Application	Ge	neral Data
Request: Public Hearing and	<b>Planning Commission</b>	April 7, 2022
consideration of a request for a	Hearing:	
Subdivision, to re-subdivide two	Approved Plat must	October 7, 2023
existing lots into two new lots of	be Recorded by:	
record		
Address:	Zone:	R-2-5/ Single and Two-Family
105 and 107 E. Randolph Avenue		Residential
Applicant:	Small Area Plan:	Potomac West/ Mount Vernon
Christopher Alan Hutchison and		Avenue Business Area Plan
Elena Caudle Hutchison, represented		
by Duncan W. Blair, attorney

SUB #2022-00001 105 and 107 E. Randolph Avenue

Figure 4b – Preliminary Plat of Subdivision. Existing lot lines to remain shown in red; proposed new lot line shown in blue.

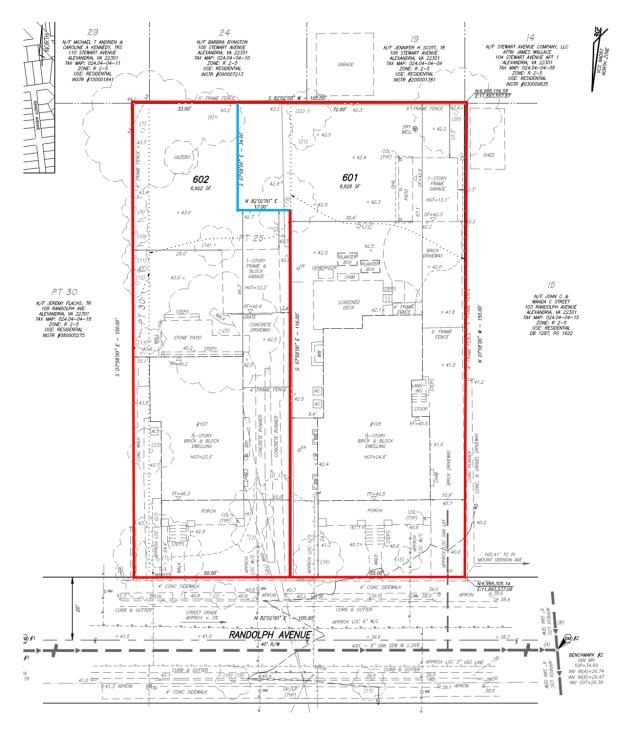
Staff recommends denial of the subdivision request for the creation of two new lots of record, Proposed Lots 601 and 602 at 105 and 107 E. Randolph Avenue, because the proposal for a property line change between the two existing lots would not meet all of the zoning subdivision standards listed above. While the proposal would meet the requirements of Sections 1710(A) and (E) through (R) as well as Sections 11-1706 and 11-1709 addressing technical subdivision requirements and Section 11-1710(D) for single-family dwellings in the R2-5 Zone, the proposal does not meet the criteria of Section 1710(B) as the proposed new lots would not be of substantially the same character as other similarly situated lots in the original subdivision. Moreover, the proposal must also conform to the City Master Plan, per Section 11-1710(C). While the proposed lots are anticipated to remain as residential use, a recommendation of the Potomac West Small Area Plan (Plan), the Plan also "recognizes the unique character of the Town of Potomac" and expresses the community's "wishes to preserve the character of the neighborhoods." Because the proposed subdivision would result in lots that would not be of substantially the same character as other similarly situated lots, the proposal would arguably not be preserving character of the neighborhoods and, therefore, unable to conform to Section 11-1710(C). Because compliance with all, not some, of these criteria is required to approve a requested subdivision, staff believes requirements of Section 11-1708(A) for considerations of overall preliminary plat approval are inadequately satisfied.

Figure 6: Proposed new lots outlined in red, area of comparison outlined in blue, and similarly situated lots outlined in black.

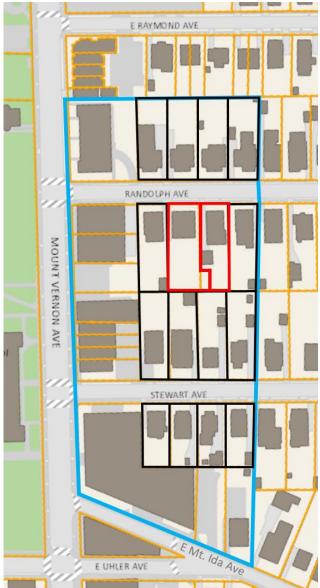
The lot analysis reveals that the proposal to re-subdivide Existing Lots PT 30/PT 25 and 502 would result in a configuration that is incompatible with other interior, similarly situated lots. A visual analysis clearly indicates there is an orderly pattern of north/south oriented rectangular lots with no midpoint deviations along shared side lot lines. Also, while both lots would continue as residential use, proposed lot 602 would not function similarly to surrounding lots as the rear yard for more than a third of the lot would be shifted toward the front of the lot 34 feet. Furthermore, while proposed lot 601 would maintain a 55-foot lot width and frontage, a dimension already larger than all other similarly situated lots, it would also increase in lot area from 8,250 square feet to 8,828 square feet, compounding its position as the largest lot within similarly situated lots. While seemingly minor, the proposed subdivision would interrupt the longstanding shared rectangular form and exacerbate incompatibility in terms of lot function and size among similarly situated lots. The resulting dissimilar conditions would compromise integrity of the collective lot form, enable a disorderly subdivision of lots, and, therefore, create an incompliance with Section 1710(B).

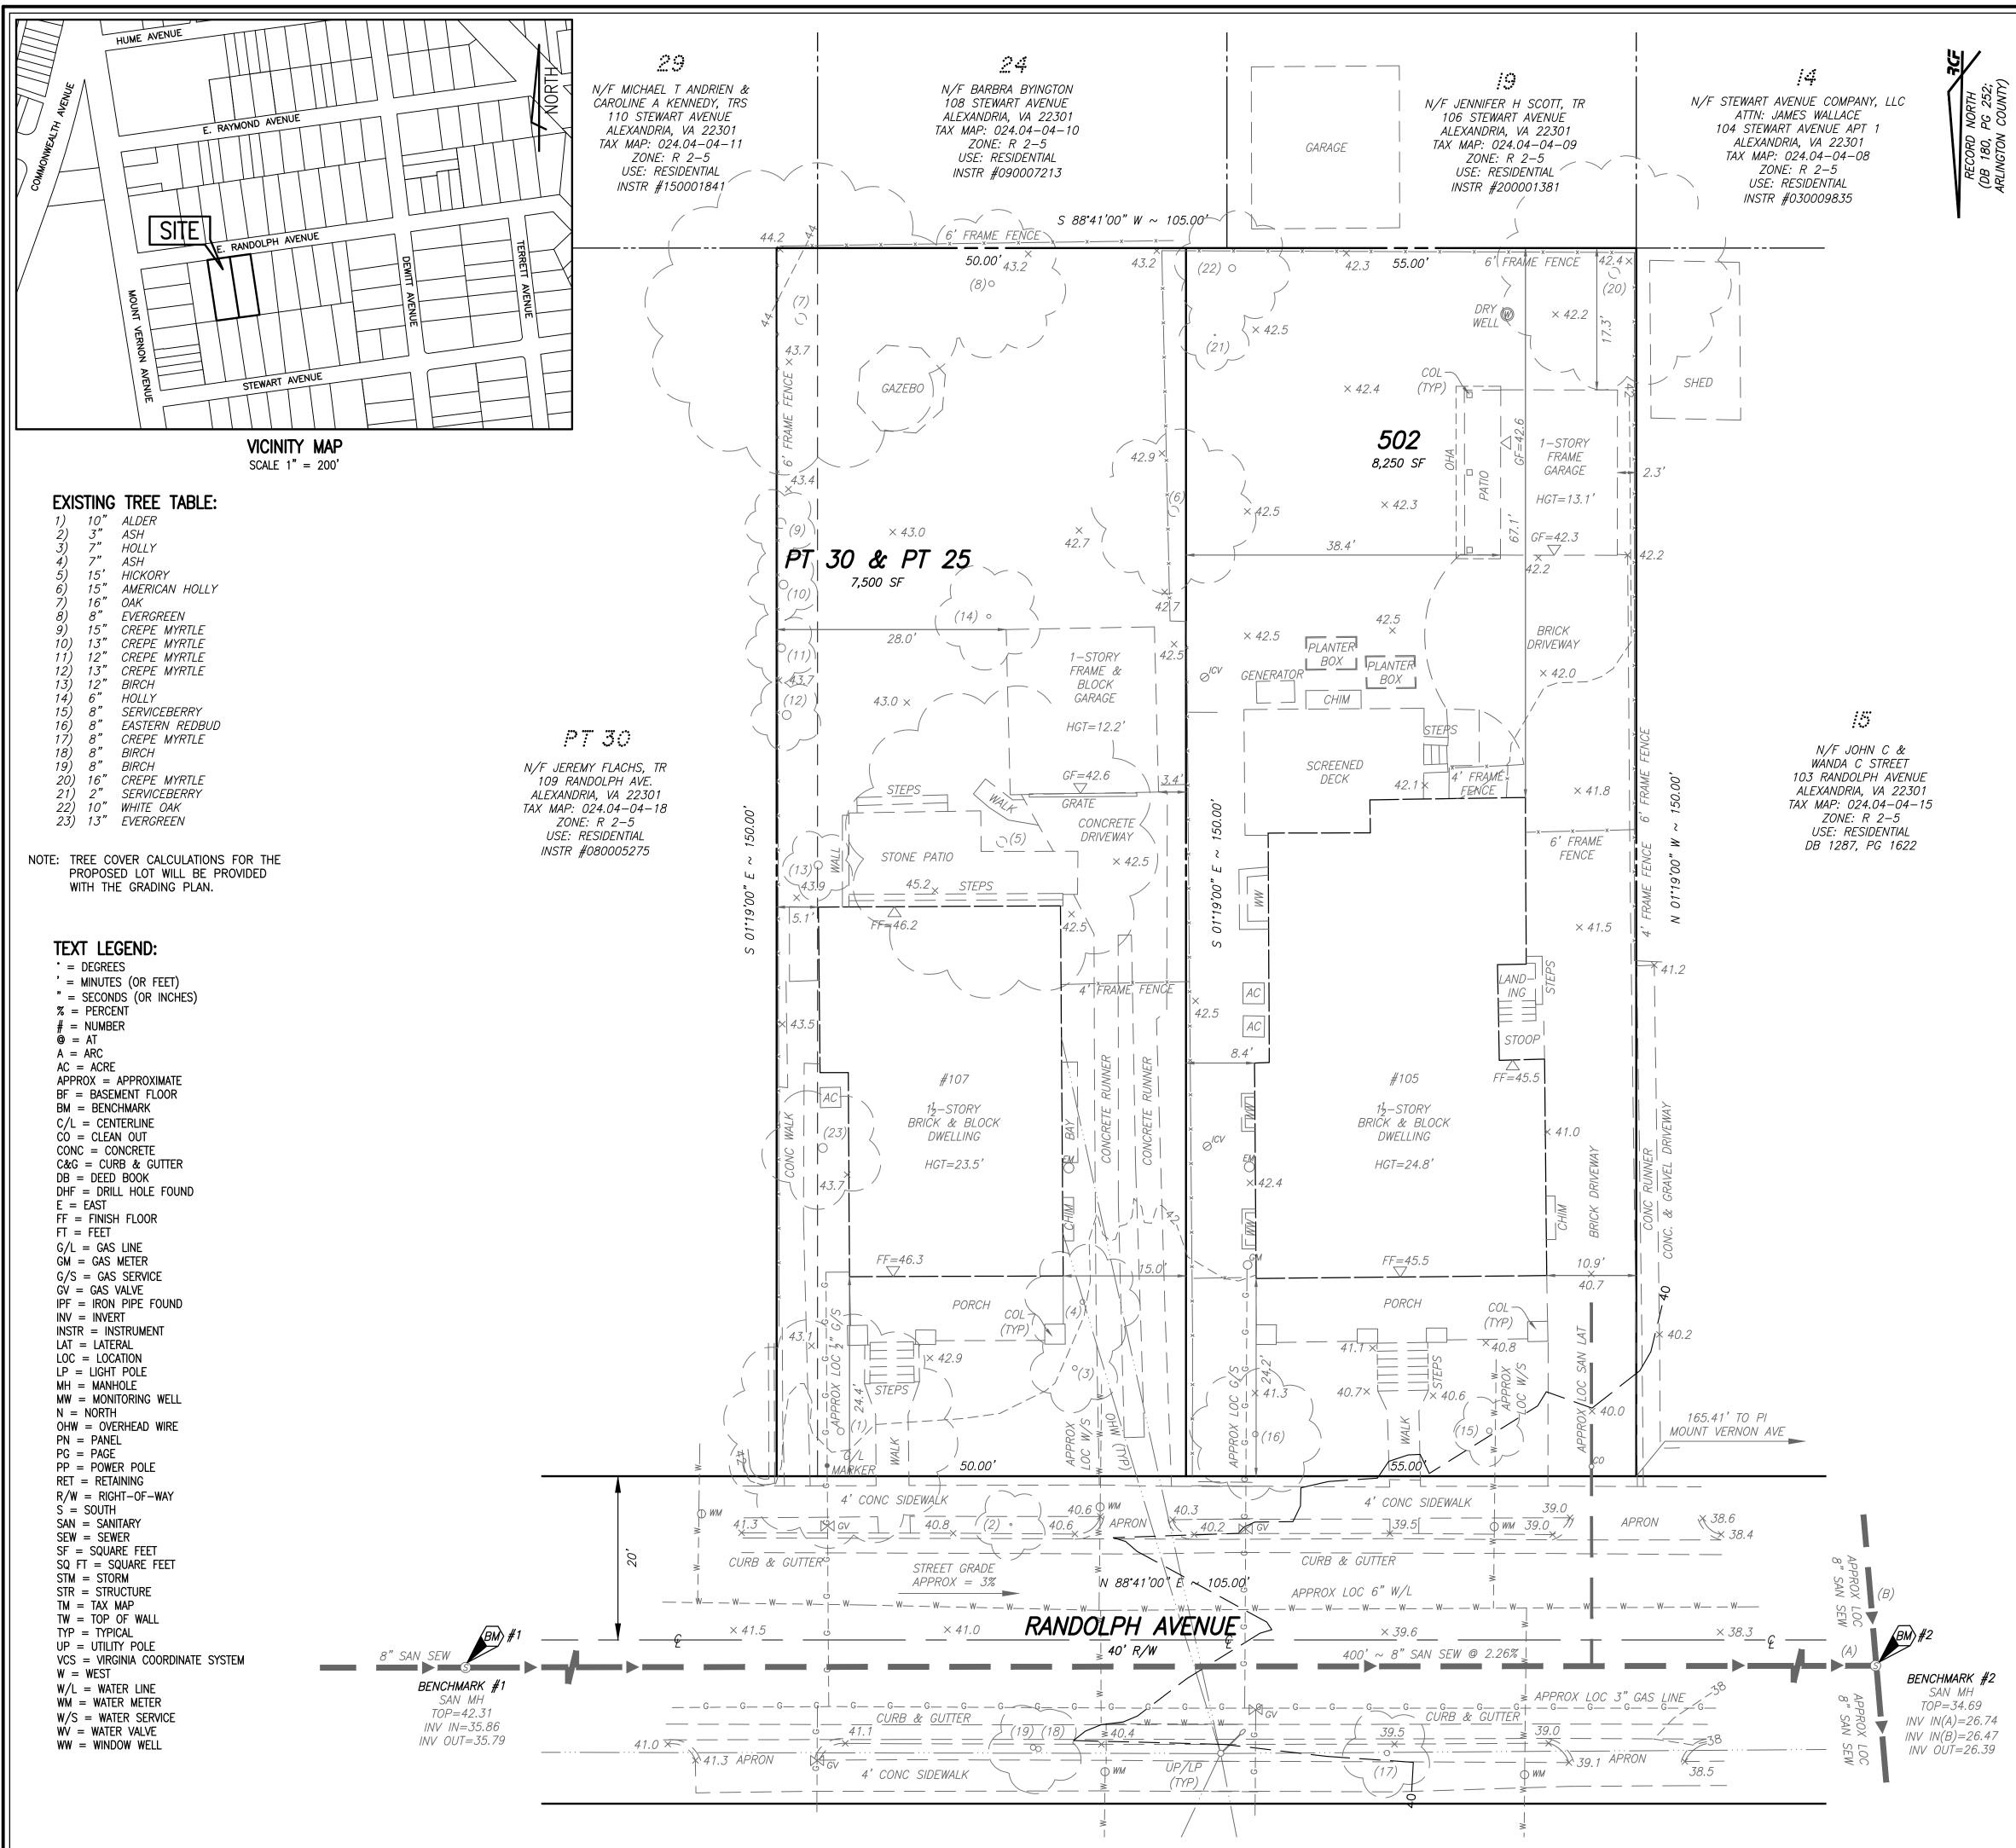
Comment 3: Please reorient the preliminary plat to show true north and adjust the proposed lot numbers accordingly.

Comment 9:	Staff recommends moving the proposed subdivision line away from existing trees. Please indicate if any trees are slated for removal.

Response: The plat is oriented to the true north or Virginia Coordinate System, North Zone and referenced in the notes and on the actual north arrow.

Response:	To accommodate staff's recommendation, we have moved the proposed subdivision line further away from existing trees, including tree "6" as identified by staff.
Comment 10:	Provide dimensions from the buildings to the nearest lot lines on all sides of the structures.
Response:	Dimensions from the nearest lot lines on all sides of the structures have been provided.

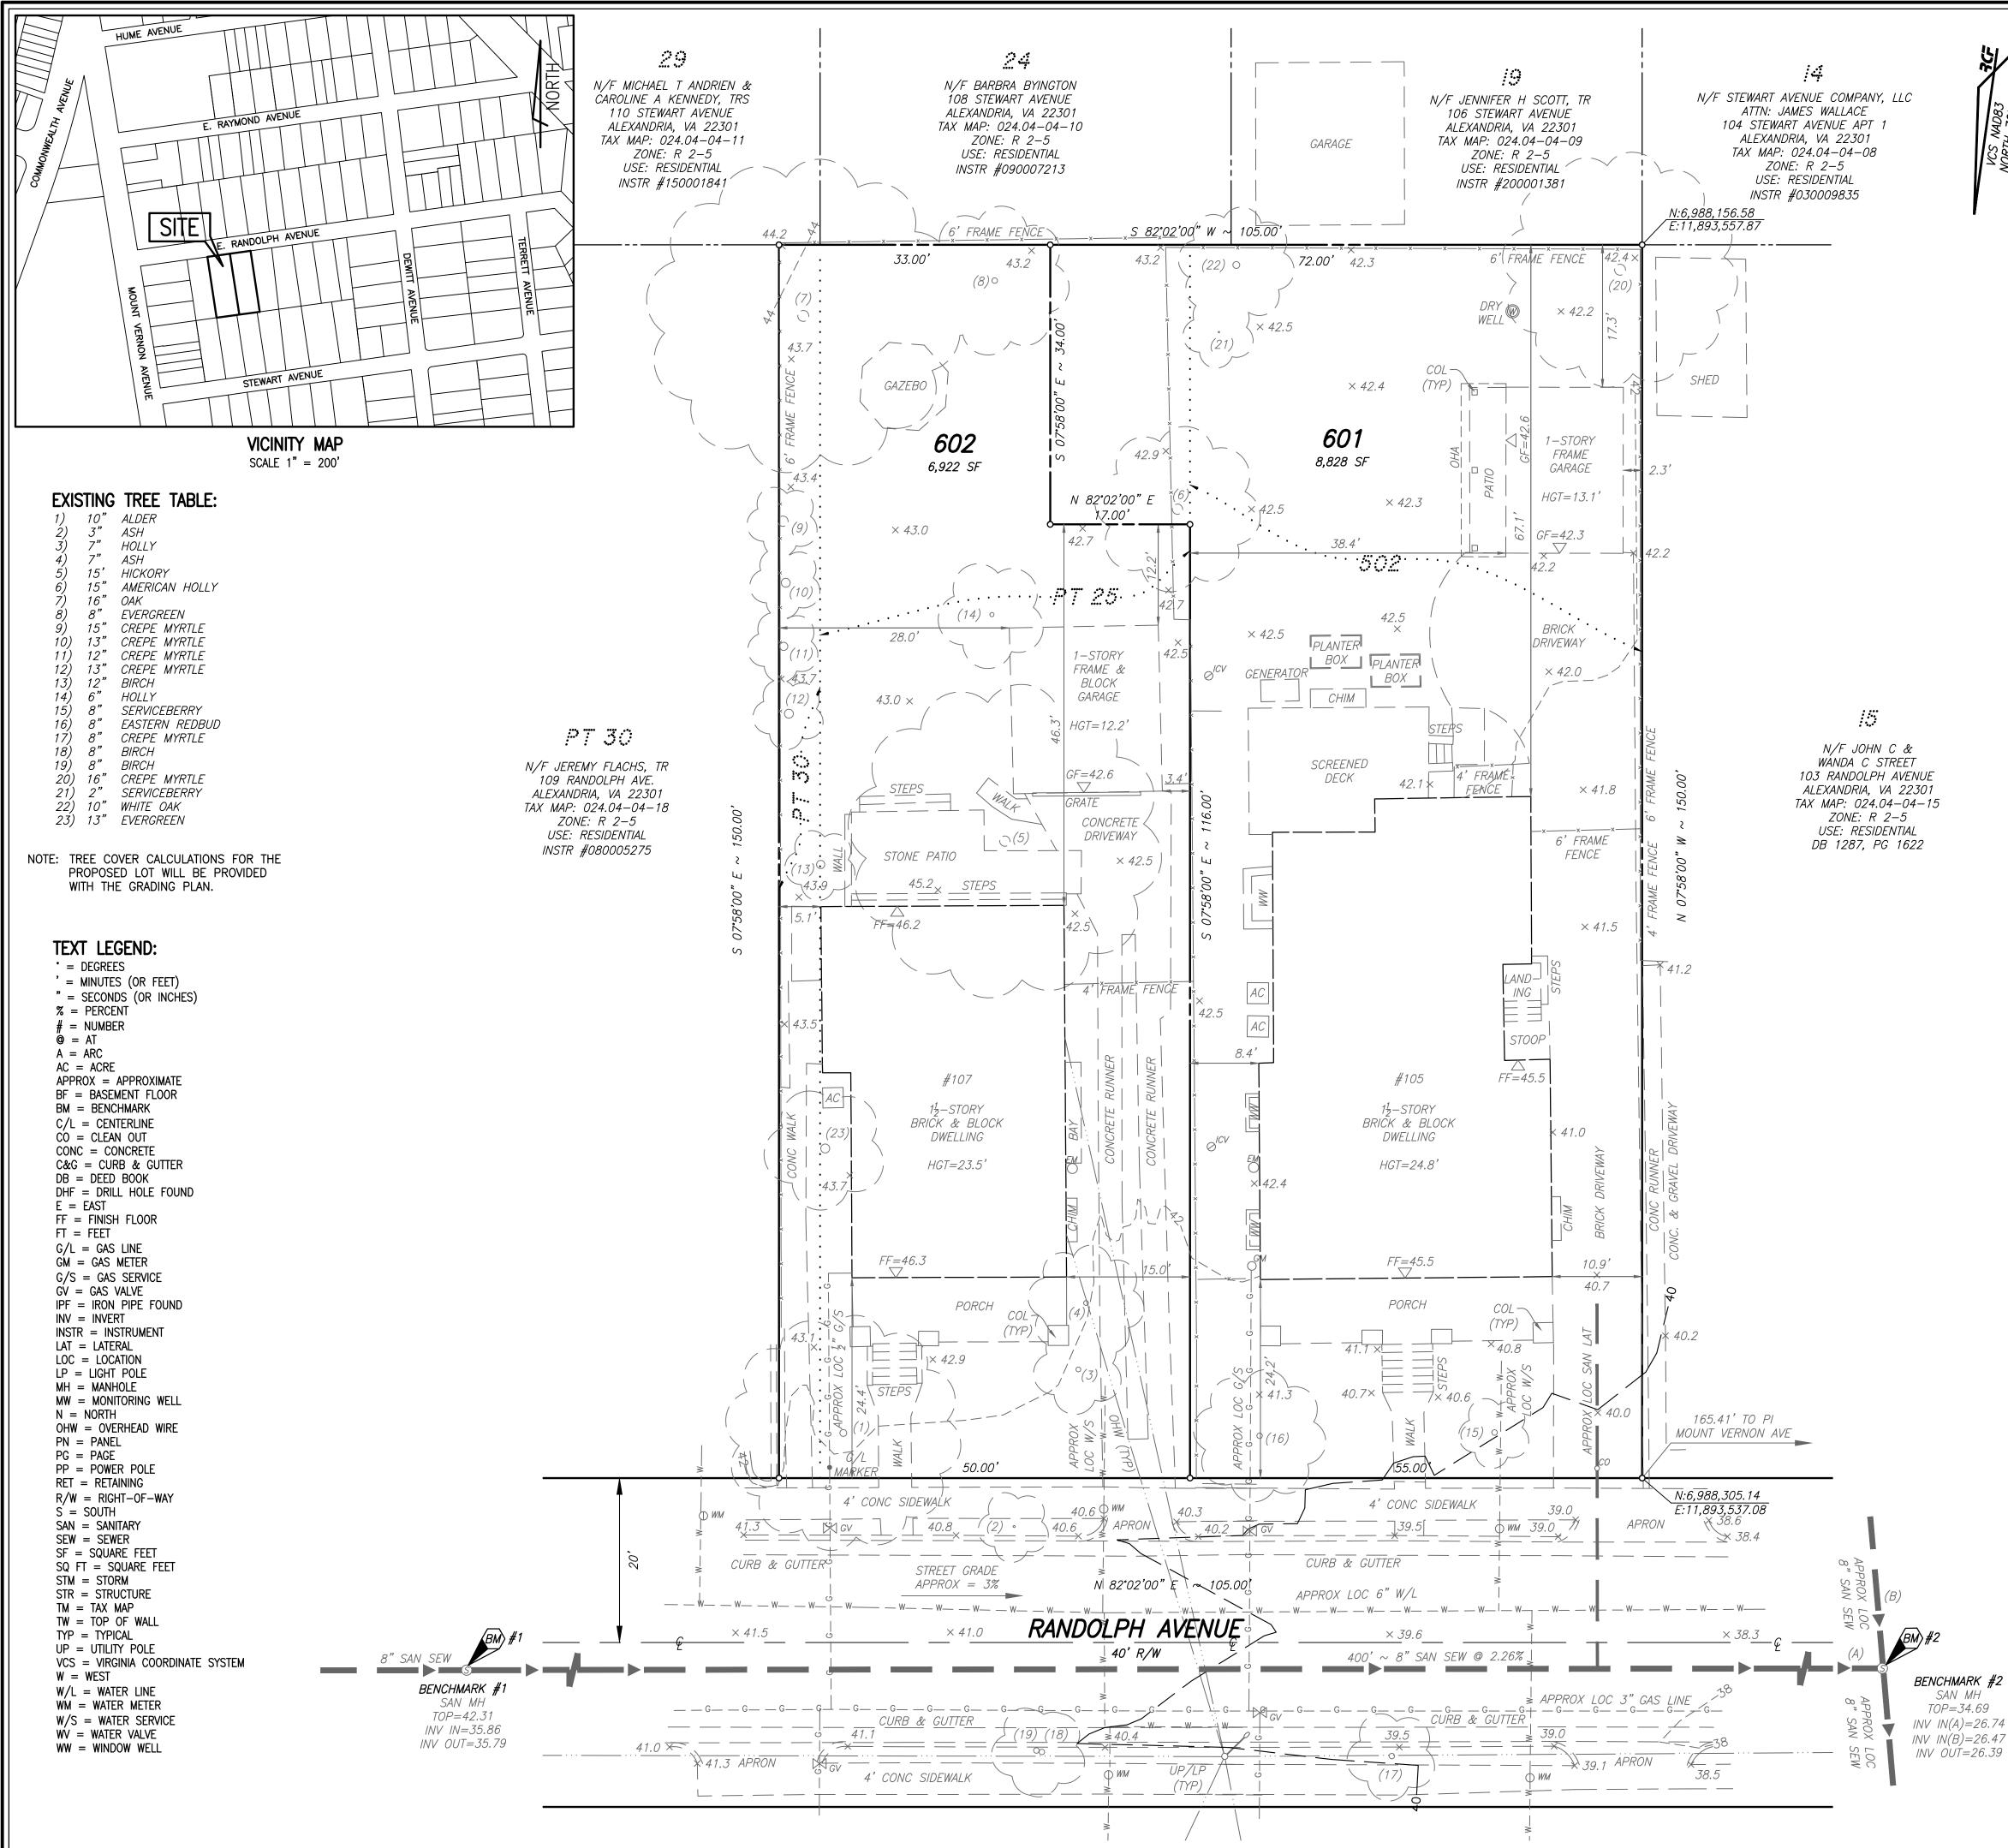
The lot numbers were adjusted and are now in the 600's.
Comment 4:	Please provide an existing conditions plat with associated property dimensions and information.

Comment 6:	Please provide the lot dimensions of the existing lots.
Response:	The lot dimensions of the existing lots are shown on the existing conditions plan, sheet 2.

Response:	A plan sheet 2 was added to show the existing conditions with property dimensions and information.
Comment 5:	Please provide separate lot areas for each existing and proposed lot.

Response:	The lot areas for the existing lots are shown on the existing conditions plan, sheet 2. The lot areas for the proposed lots are shown on the preliminary subdivision plat, sheet 1.
